**WILSONVILLE CITY HALL
DEVELOPMENT REVIEW BOARD PANEL A**

MONDAY, FEBRUARY 8, 2016 - 6:30 P.M.

A. Resolution No. 323.

Exhibit A1
Staff Report
Wilsonville Planning Division
Advance Road Middle School

LU1.01

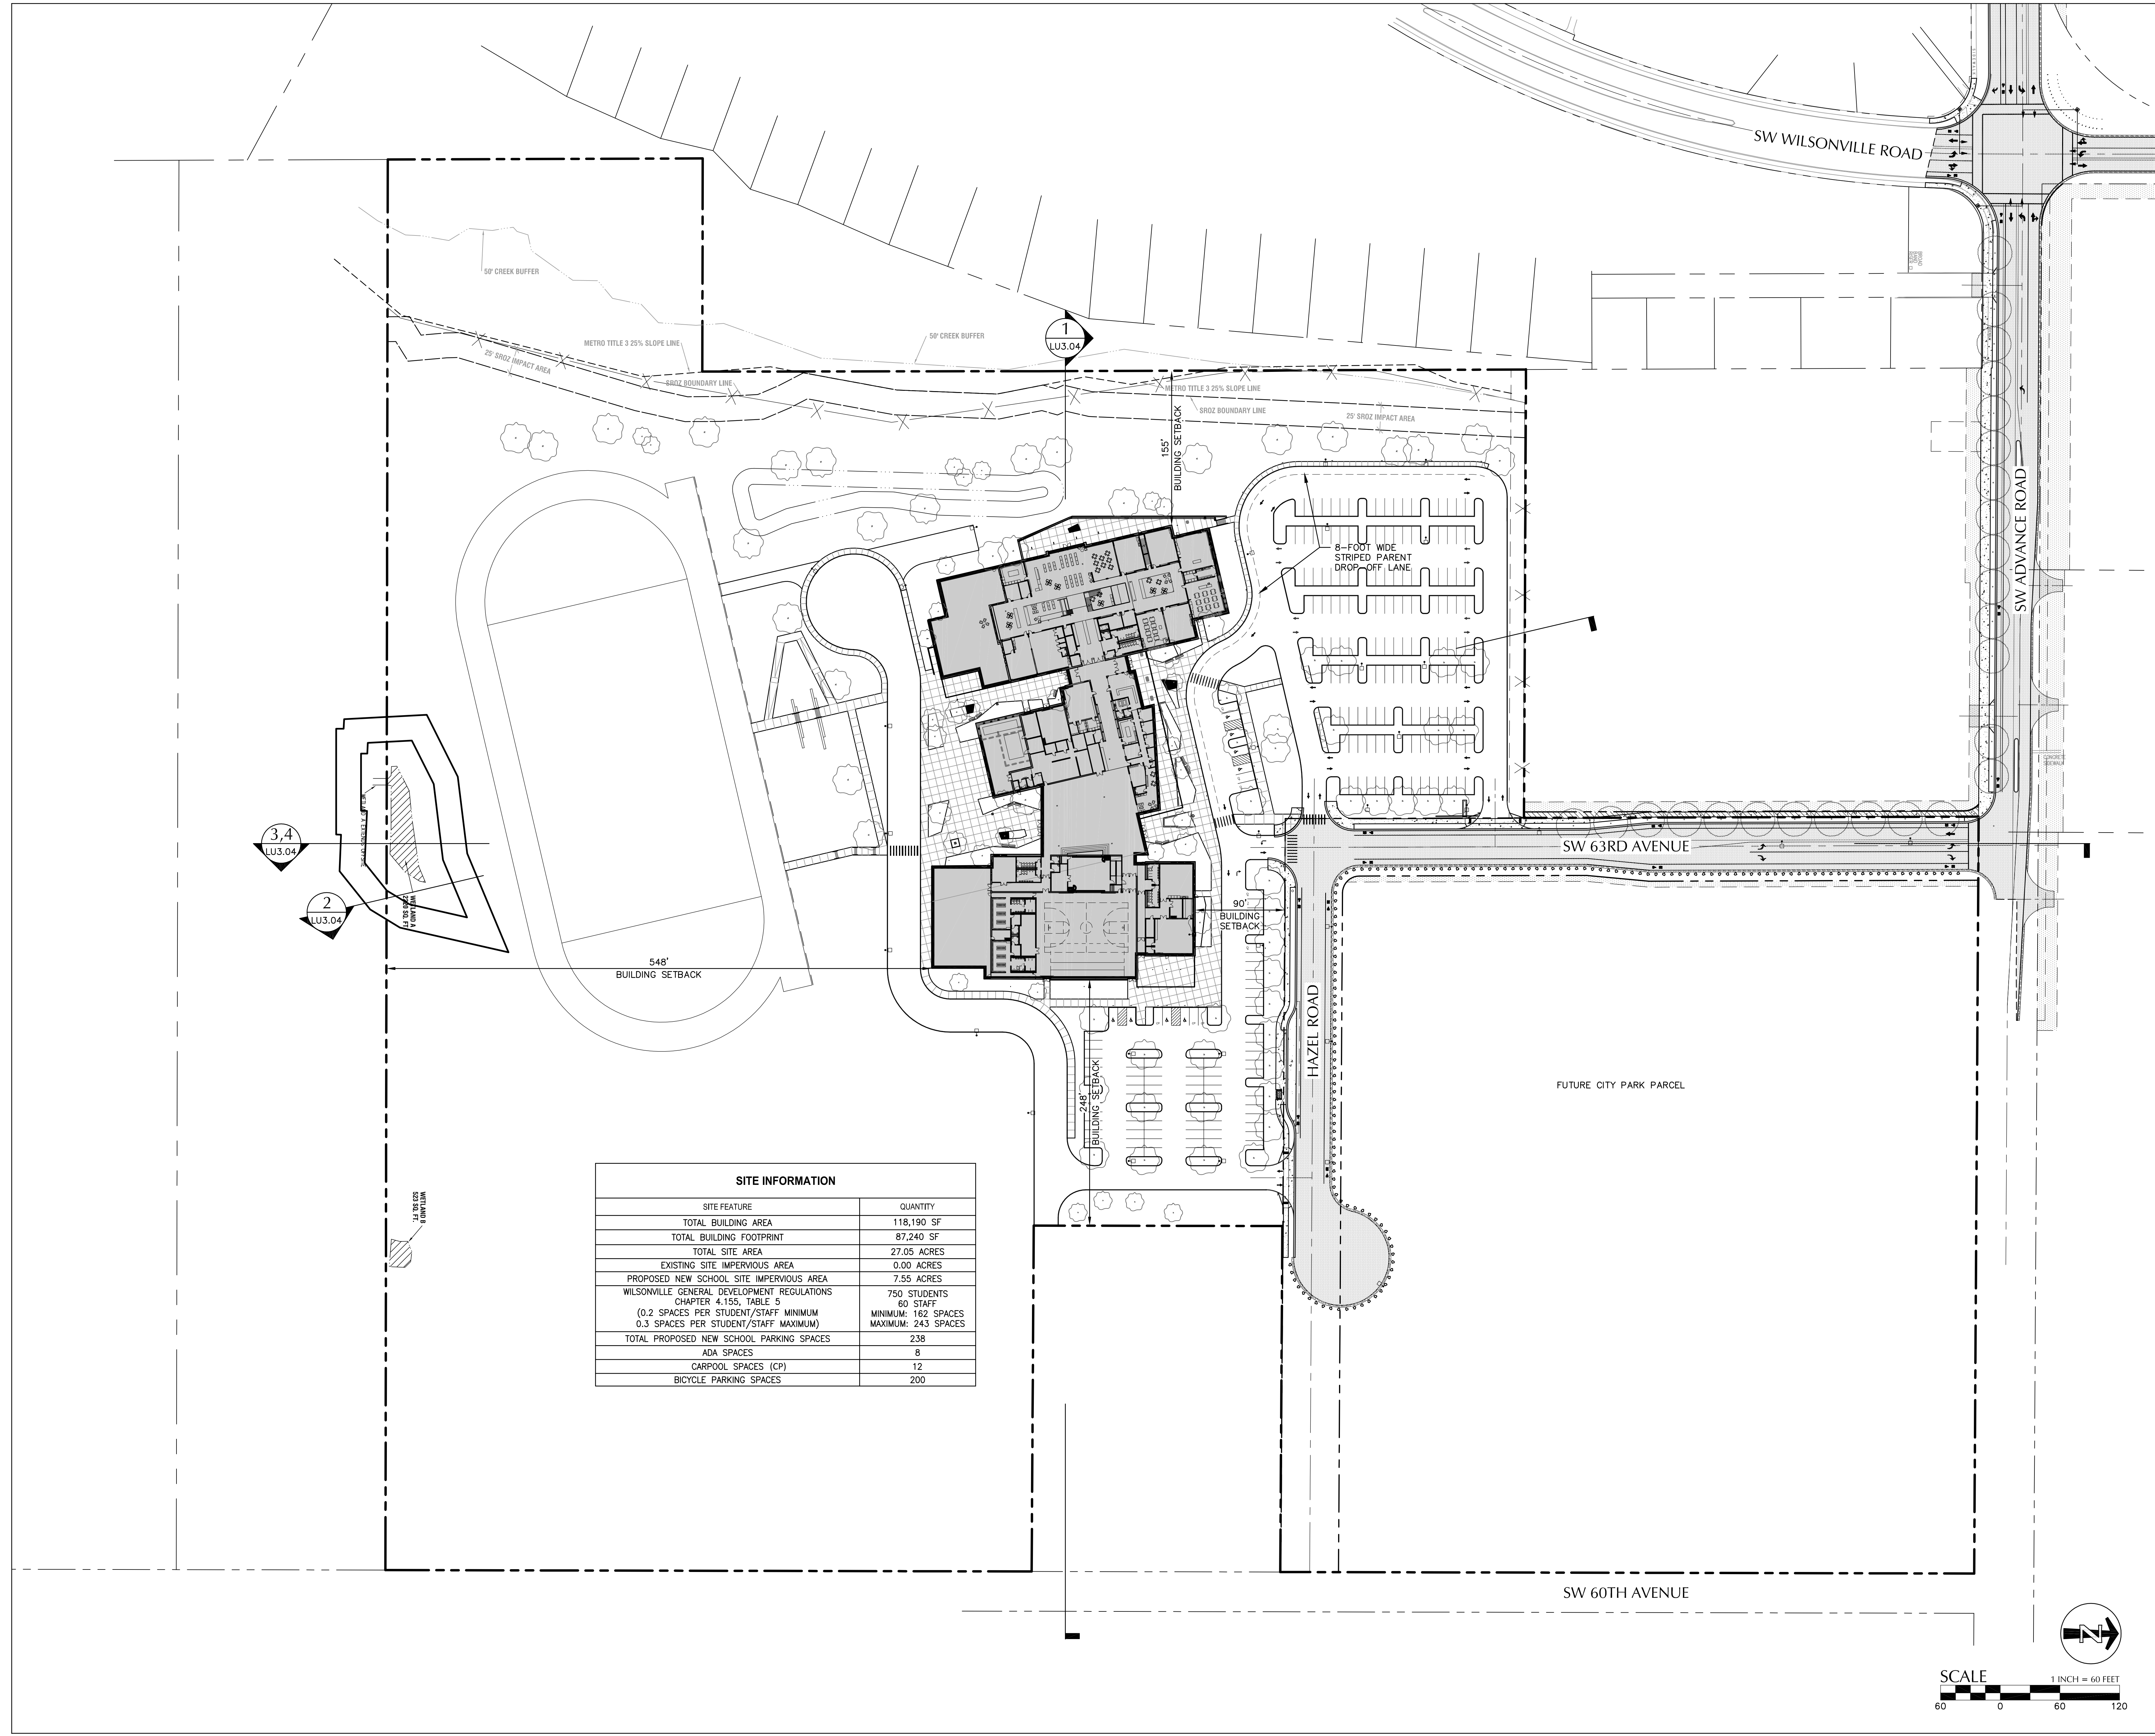
Response: *This is shown on Sheet LU1.01.*

Response: *This is shown on Sheets LU1.01, LU1.03, and LU1.03A. The carpool/vanpool spaces are labeled "CP."*

LU1.06

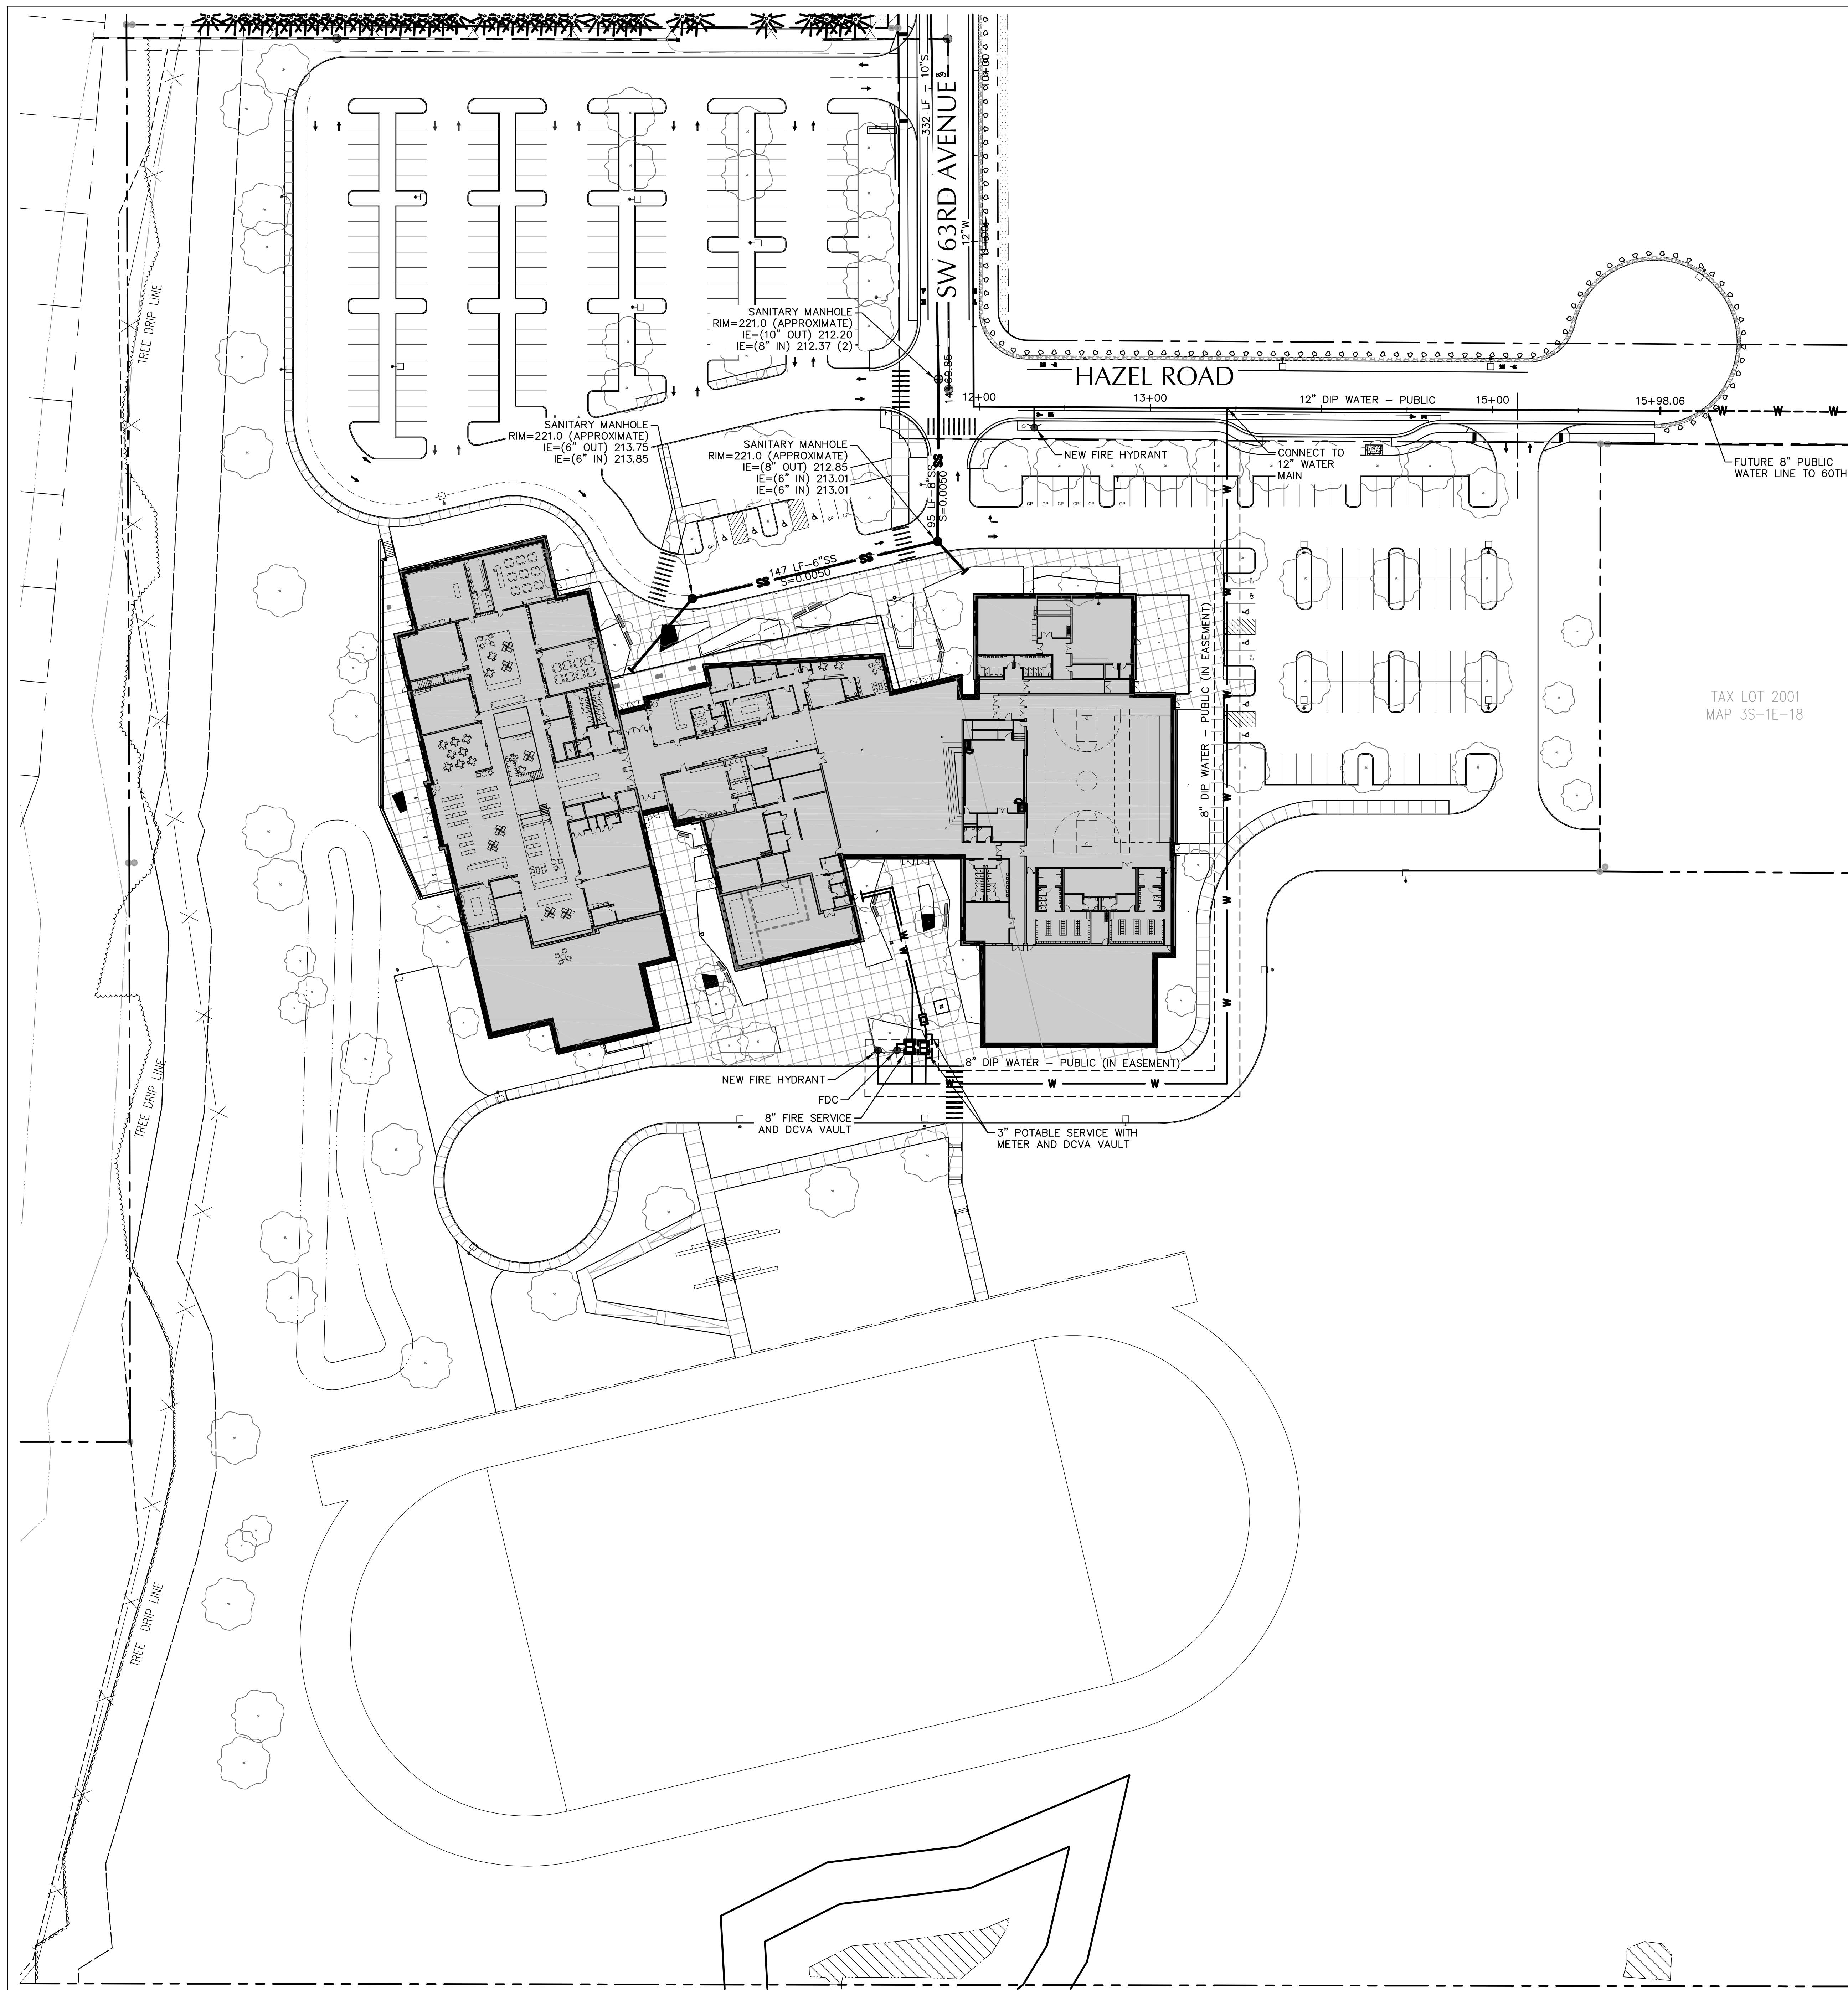
Details of Finding: The site utility plan, sheet LU1.06 of Exhibit B2, indicates the proposed method of sanitary and storm sewer disposal.

LU2.01

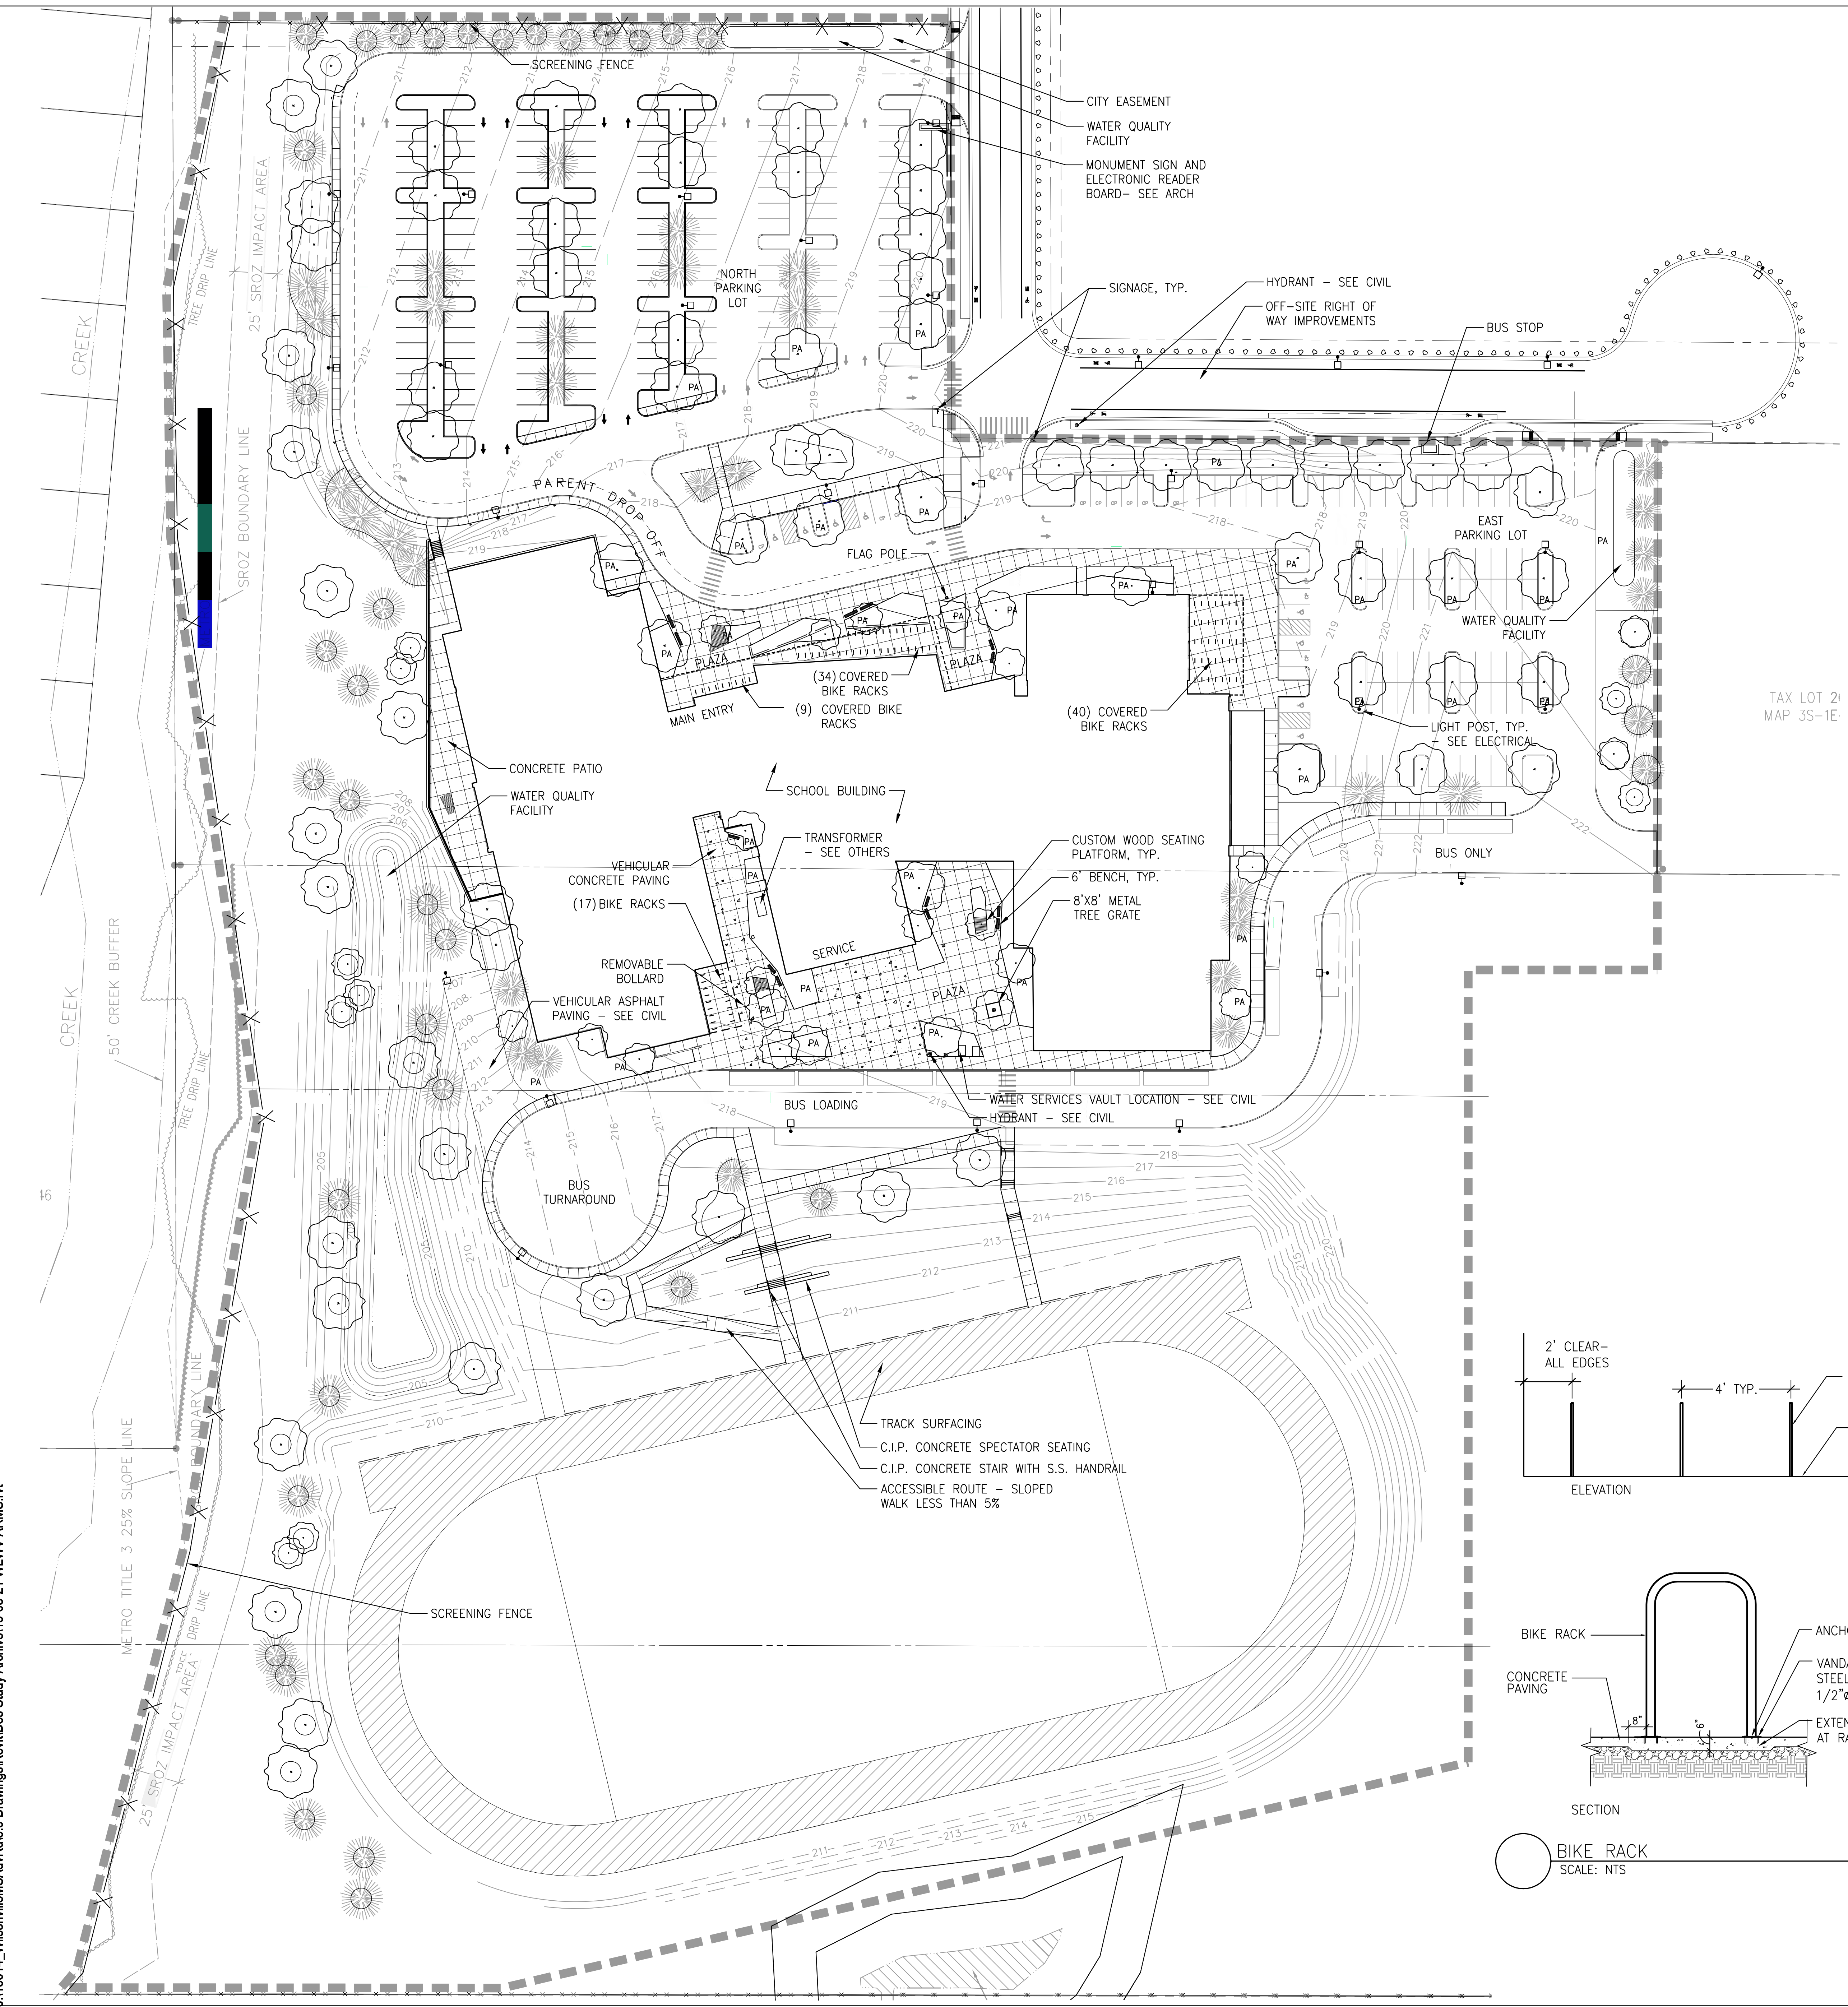
Details of Finding: Sheet LU2.01 of the applicant's plan set, Exhibit B2, shows spaces 2 feet by 6 feet.

Details of Finding: Sheet LU2.01 of the applicant's plan set, Exhibit B2, shows spaces oriented as to be each accessible without moving another bicycle.

Details of Finding: Sheet LU2.01 of the applicant's plan set, Exhibit B2, shows a minimum aisle width of 5 feet.

Details of Finding: Sheet LU2.01 of the applicant's plan set, Exhibit B2, shows racks spaced so as to avoid obstructions and able to be used properly.

Details of Finding: Sheet LU2.01 of the applicant's plan set, Exhibit B2, indicated bike racks will be securely anchored with vandal proof stainless steel expansion anchors.

Details of Finding: Applicant's sheet LU2.01 of Exhibit B2 indicates landscaping will continue to cover 42 percent of the development site (444,473 square feet of the 772,427 square feet). Landscaping is proposed in more than three distinct areas.
